HISTORIC AND DESIGN REVIEW COMMISSION

HDRC CASE NO: 2022-293
ADDRESS: 1024 N CHERRY
LEGAL DESCRIPTION: NCB 512 BLK 25 LOT W 99.55 FT OF 3
ZONING: R-4, H
CITY COUNCIL DIST.: 2
DISTRICT: Dignowity Hill Historic District
APPLICANT: Joseph Munoz
OWNER: Joseph Munoz
TYPE OF WORK: Construction of a rear addition, exterior modifications, fenestration modifications, porch modifications, roof form modifications, window replacement and siding modifications
APPLICATION RECEIVED: July 27, 2022
60-DAY REVIEW: Not applicable due to City Council Emergency Orders
CASE MANAGER: Edward Hall

Historic and Design Review Commission
Design Review Committee Report

SITE PLAN & FLOOR PLAN

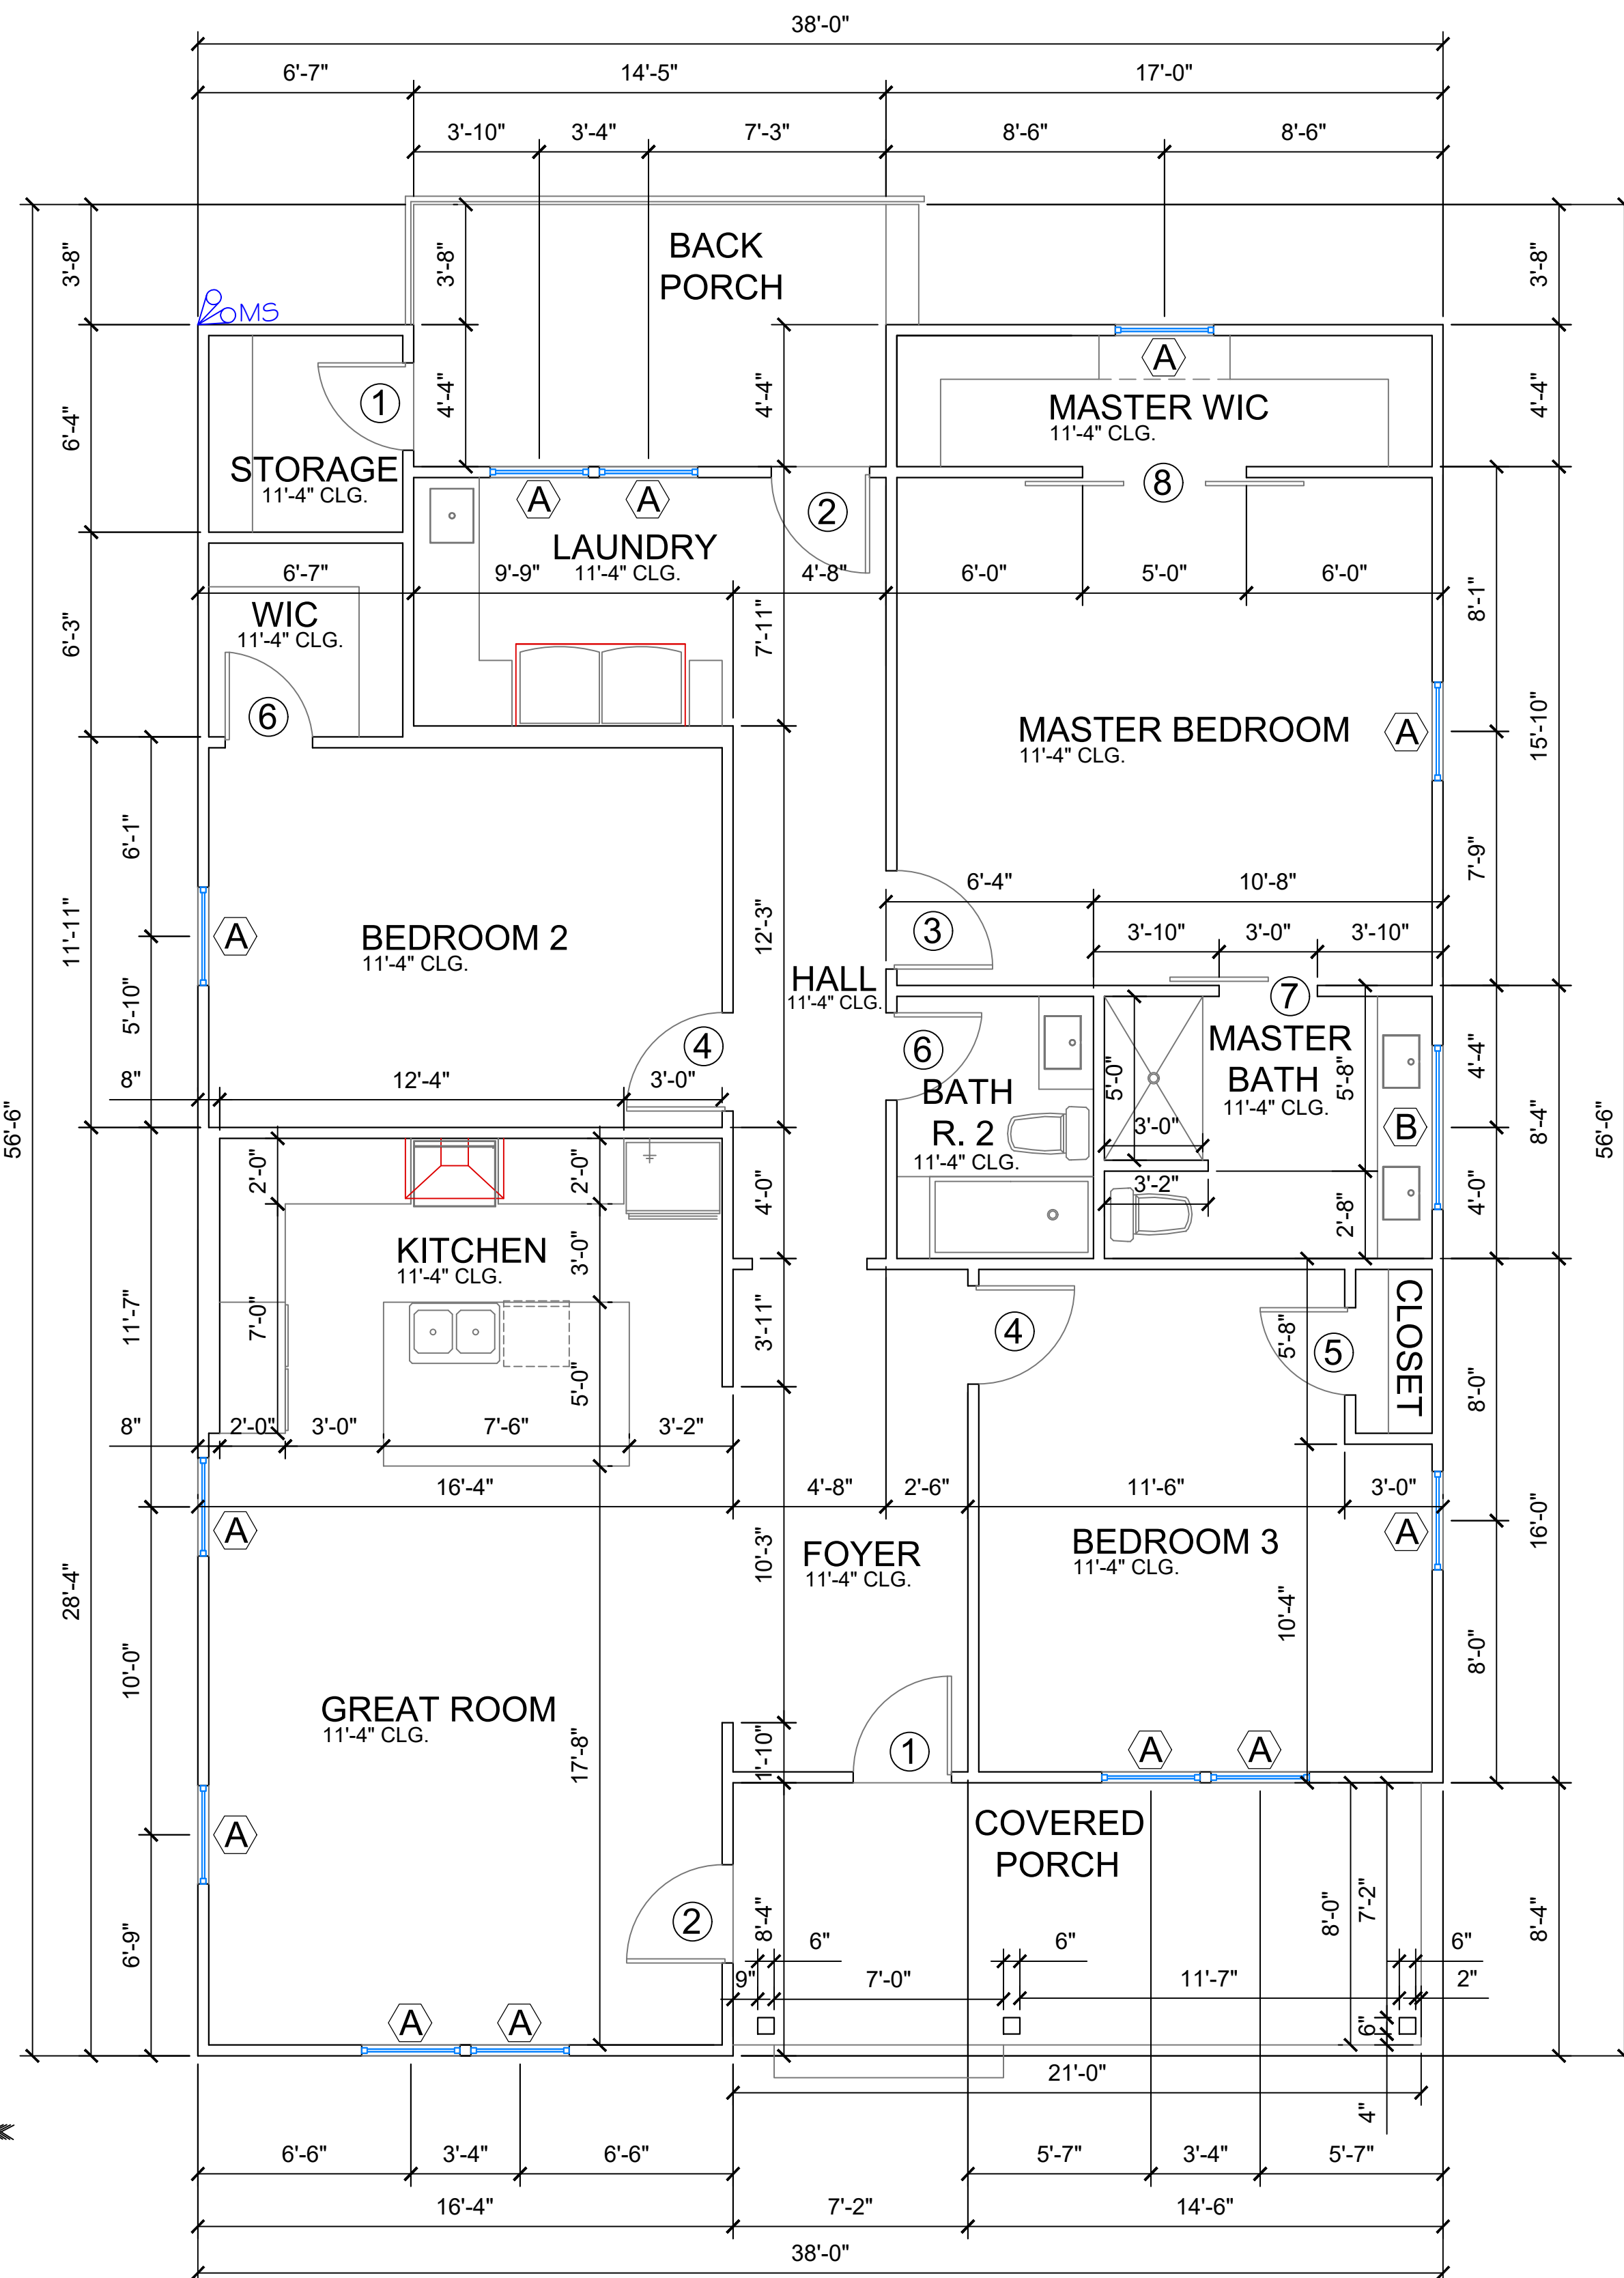
- f. FENESTRATION MODIFICATIONS – The applicant has proposed fenestration modifications that include modifying the existing, historic fenestration pattern of the historic structure by modifying existing door and window openings on the west, north and south facades. Within this request, the applicant has proposed to modify the head and sill heights, widths, opening locations, and profiles of various windows on each façade. The applicant has proposed to return the front façade to its original configuration, include door and window locations. The Guidelines for Exterior Maintenance and Alterations 6.A. note that existing window and door openings should be preserved and that new openings should not be created on the primary façade or where visible from the public right of way. Additionally, the Guidelines note that original opening should not be increased or reduced in size to fit stock window sizes. Staff finds the proposed modifications to be inappropriate and inconsistent with the Guidelines. Staff finds the original sizes, locations and profiles of all windows and doors should be restored.

- k. REAR ADDITION – The applicant has proposed to construct a rear addition to feature approximately 350 square feet. The proposed rear addition will feature an open air, covered porch, a front facing roof gable, composite siding and aluminum windows.

- l. REAR ADDITION – The Guidelines for Additions 1.A. notes that additions should be sited to minimize view from the public right of way, should be designed to be in keeping with the existing, historic context of the block, should feature similar roof forms, and should feature a transition to differentiate the new addition from

the historic structure. Additionally, the Guidelines for Additions 1.B notes that additions should be subordinate to the principal façade of the historic structure, should feature a footprint that responds to the size of the lot, and should feature an overall height that is generally consistent with that of the historic structure. The applicant has proposed an addition that does not feature a differentiating element between the historic structure and the rear addition as well as an addition that features a ridge line that is greater than that of the historic structure. Staff finds the proposed rear addition to be inconsistent with the Guidelines.

7. Staff does not recommend approval of item #7, the construction of a rear addition, based on findings i through m. Staff recommends the following for the rear addition:

- i. That the rear addition feature a setback from the walls of the historic structure or a separating element, such as a vertical trim piece.
 - ii. That the siding and trim feature a smooth profile and that siding feature an exposure of four inches.

- iv. That the proposed addition feature a massing that is subordinate to that of the historic structures, including a reduced roof form that does not impact the primary ridge line of the historic structure. The rear addition's roof should not impact the primary, front façade of the historic structure.

FRONT ELEVATION
SCALE: 1/4" = 1'

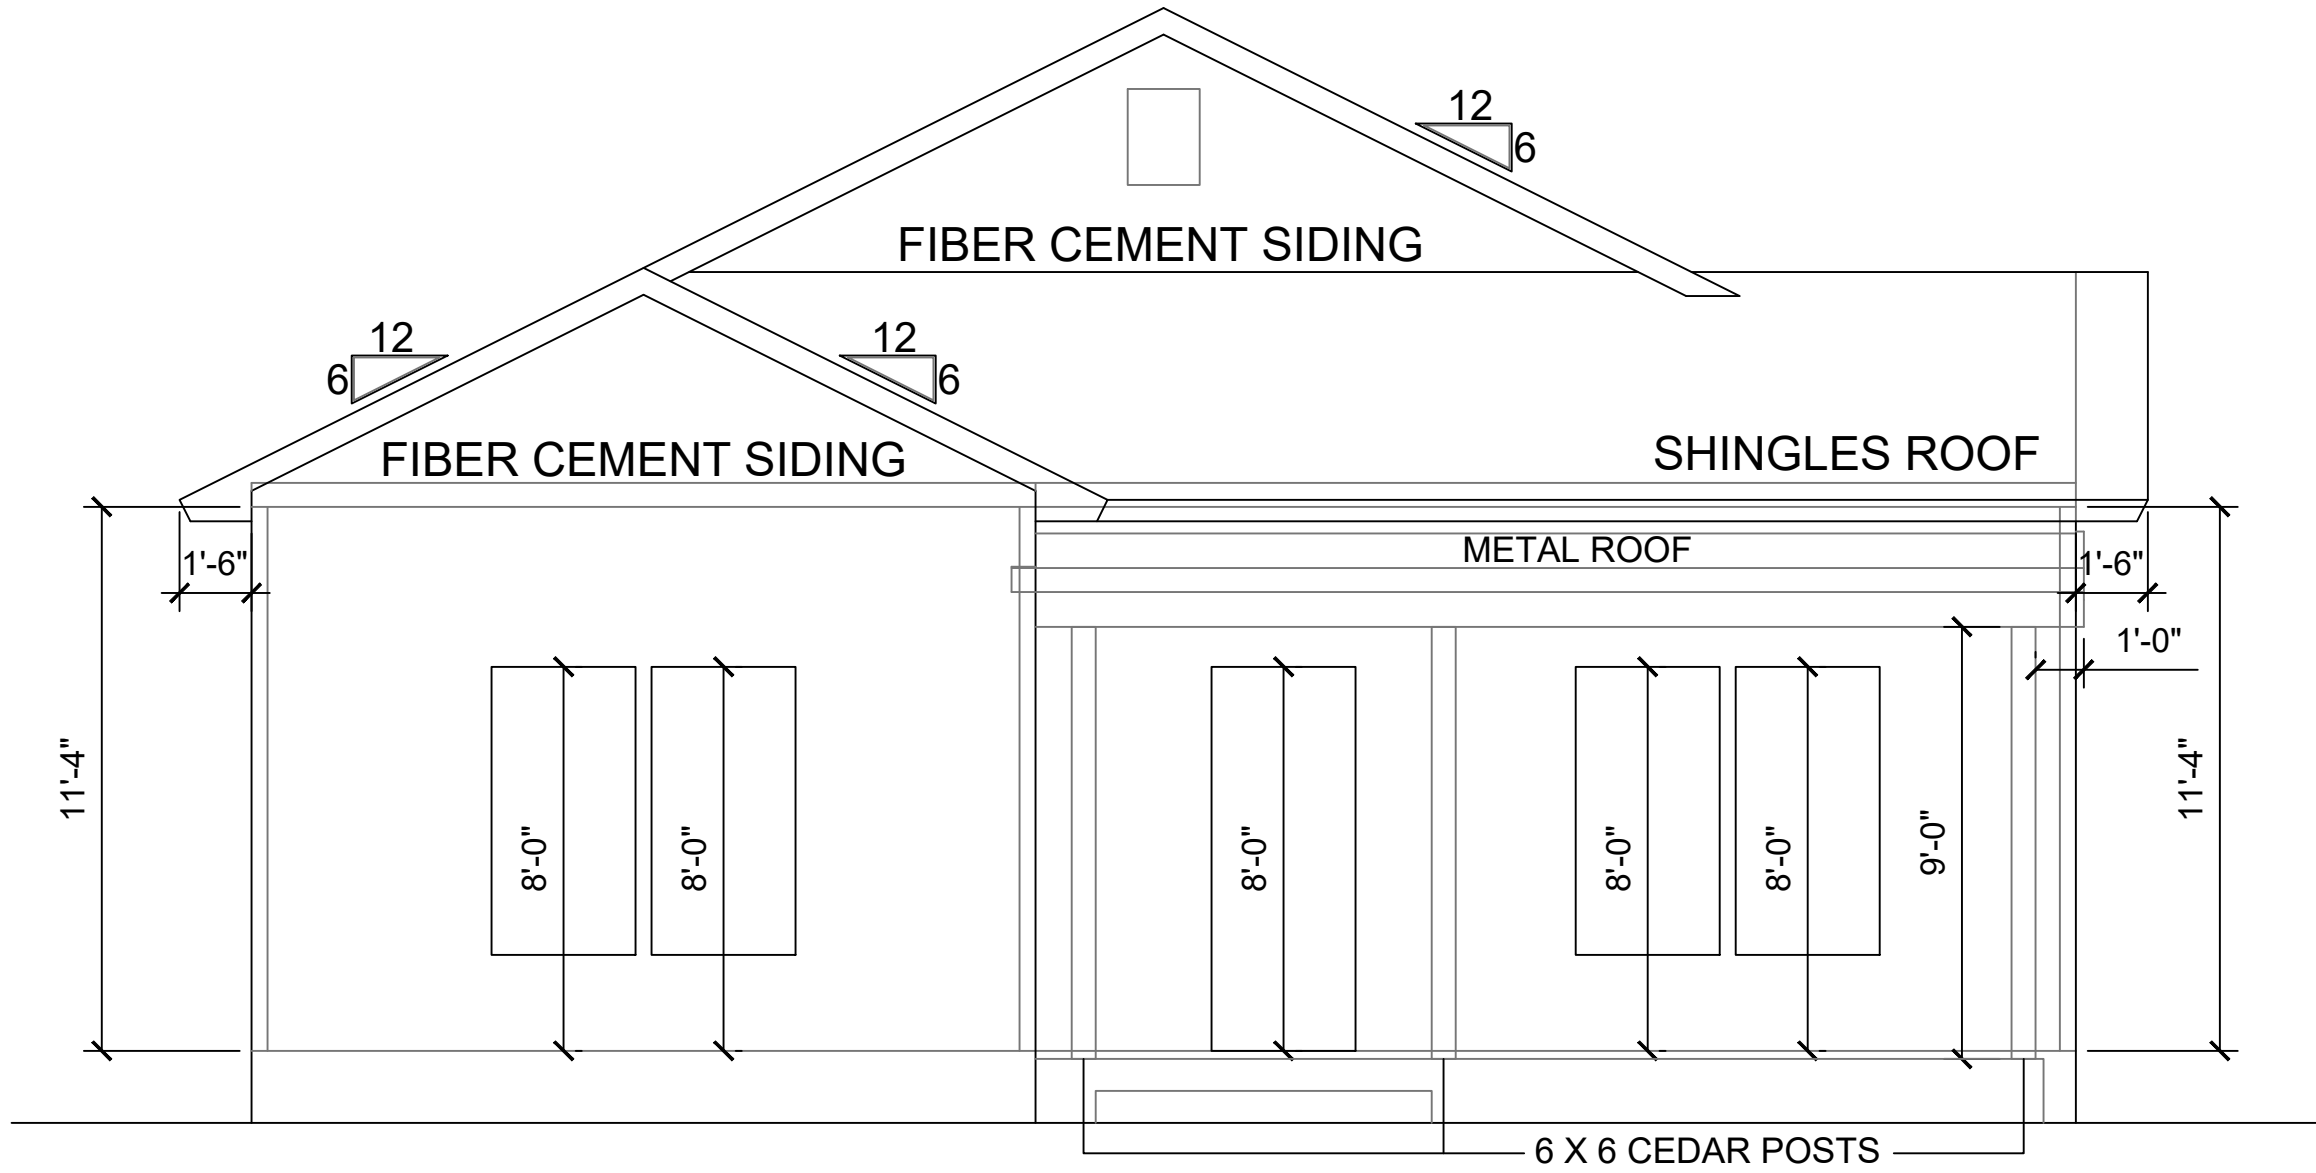
GV: The front facade is the most important

JF: Return windows to the original sizes and locations. One over one with no faux divided lites

JF: Return to original window size and location. Move door in line with sidewalk. Traditional style door.

- ii. That the frieze board be reinstalled at the previous profile.
2. Staff does not recommend approval of item #2, modifications to the original fenestration pattern including both windows and doors, based on finding d. Staff recommends the original sizes, locations and profiles of all windows and doors be restored.

REVISED FRONT ELEVATION TO ADDRESS COMMENTS RECEIVED AT THE DRC
SITE VISIT ON JUNE 8, 2022.
